Product Change Notification / ASER-06ZMCM207

CCB 4630 Final Notice: Qualification of STA as an additional assembly site for selected LAN9303, LAN9210 and LAN9211 device families available in 56L VQFN (8x8x0.9mm) package.

Pre and Post Change Summary

PCN #: ASER-06ZMCM207

ASE

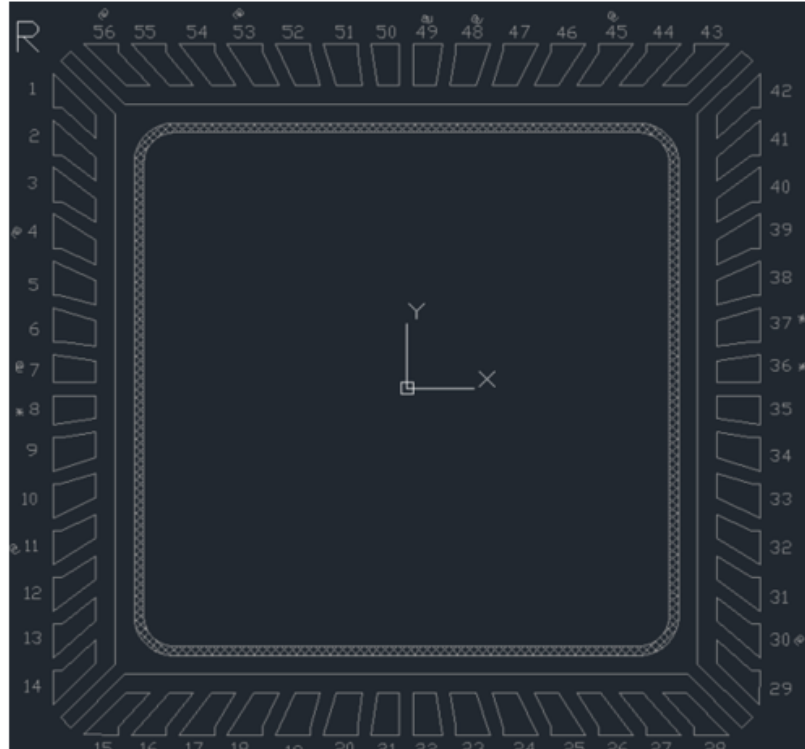
Wire material	PdCu	Au	PdCu	Au	CuPdAu
Die attach material	EN-4900F		EN-4900F		8290
Molding compound material	G631B		G631B		G700E
Lead frame material	C194		C194		C194
Lead frame lead-lock	No		No		No
	See Pre and Post Change Summary for comparison.				
Lead frame paddle size	240x240 mils		240x240 mils		236x236 mils

Lead frame Comparison
